UNITED STATES PATENT AND TRADEMARK OFFICE

10/588,832

Office Action Summary

LYON, ROLAND

Peer – Figure 3 (magnified)

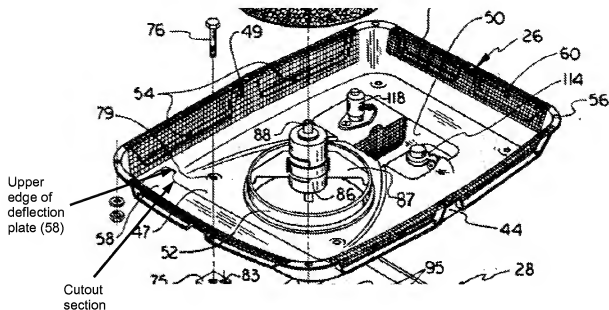
Consider claim 7. Peer discloses that the deflector plate (58) contains a cut-out section in an upper edge (see Figure 3 magnified below).

Peer – Figure 4

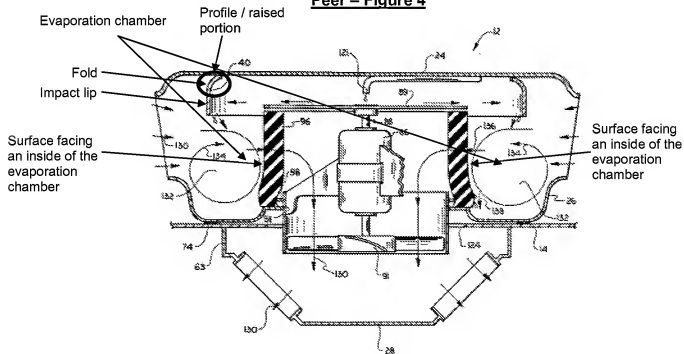
Consider claims 1, 16 and 20. Peer discloses an evaporative air conditioner (12) for delivering conditioned air to vehicle cabins, the air conditioner (12) comprising: an evaporation chamber defined by housing assemblies (24, 26) (see Figure 4 below) (col. 2, L 39-56), air directed towards the cabin via air outlet (68) while passing through at least one wet filter (96); a discharge nozzle (121) and vaporizer disc (89) (corresponding to the claimed mister); an impingement ring member (40) (corresponding to the claimed run-off in the vicinity of the filter) (col. 5, L 5-35); and a guide plate (58) (corresponding to the claimed deflector comprising a deflector plate) (col. 3, L 20-23) (see also Figs. 1-4).

Consider claim 8. Peer discloses a component of the mister being a discharge nozzle (121) (corresponding to the claimed injector) positioned to discharge water onto the vaporizer disc (89) and to the run off (40), the water then contacting the incoming airflow (130) as shown at (134) (see Figure 4), which is at an outlet of the deflector (col. 4, L 46-55; col. 5, L 15-37; Figs. 2 & 4).

Consider claim 3. Lyon and Peer disclose the invention as claimed, and Peer further discloses the run-off (40) including at least one impact lip (see Figure 4). While neither Lyon nor Peer disclose the impact lip extending into an upper portion of the filter in a plane substantially coincident with the plane of the surface of the filter, it would have been an obvious mechanical expedient to an ordinarily skilled artisan at the time of the invention to modify the evaporative air conditioner disclosed by Lyon and Peer so that the impact lip of the run-off extended into an upper portion of the filter in order to more effectively guide the water mist directly to the top of the filter so that water droplets are more successfully separated from the conditioned air flow; the water collected to be

Consider claim 4. Peer discloses that the impact lip is formed by a fold (see Figure 4 below where the fold is indicated as the bend point of the run-off leading to the impact lip) made in a the run-off (40) (corresponding to the claimed drop-out plate), fastened beneath top wall (35) (corresponding to the claimed closing cover) of the evaporation chamber (col. 2, L 56-col. 3, L5; see Figure 4 below). It should be noted that applicant disclosed (specification, p.10, L 9-10) that "the mist converge[s] towards *drop-out plate (7) forming run-off*", and therefore the examiner has determined that the run-off (40) disclosed by Peer constitutes a drop-out plate as discussed.

Consider claim 5. Peer discloses that the drop-out plate has a profile / raised portion, i.e. the indicated area is raised above the impact lip (see Figure 4 below).

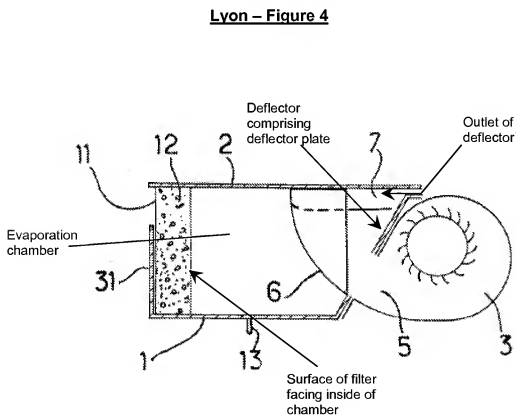
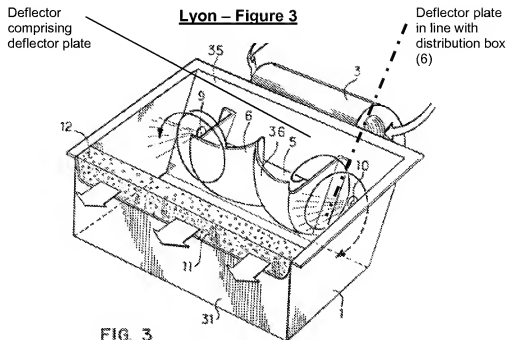
Consider claims 1, 16 and 20. Lyon discloses an evaporative air conditioner for vehicle cabins (ABST; col. 3, L 52-59), the air conditioner comprising: an evaporation chamber (see Figure 1 below), an outlet (11), at least one wet filter (12), a mister (col. 3, L 12; Fig. 5) made up of nozzles (9, 10), a deflector (see Figures 3 & 4 below) and a surface of the wet filter (12) facing an inside of the evaporation chamber (col. 2, L 62-col. 3, L 12, 39-67; Figs. 3-7).

Consider claim 6. Lyon discloses a delivery air distribution box (6); the deflector comprising a deflector plate (see Figures 3 & 4 below) running in line with the distribution box (6) (see Figure 3 below) (col. 2, L 66-col. 3, L 38).

Consider claim 8. Lyon discloses that the mister made up of nozzles (9, 10) (corresponding to the claimed at least one injector) positioned in relation to the deflector, and an outlet of the deflector (see Figures 3 & 4 below).
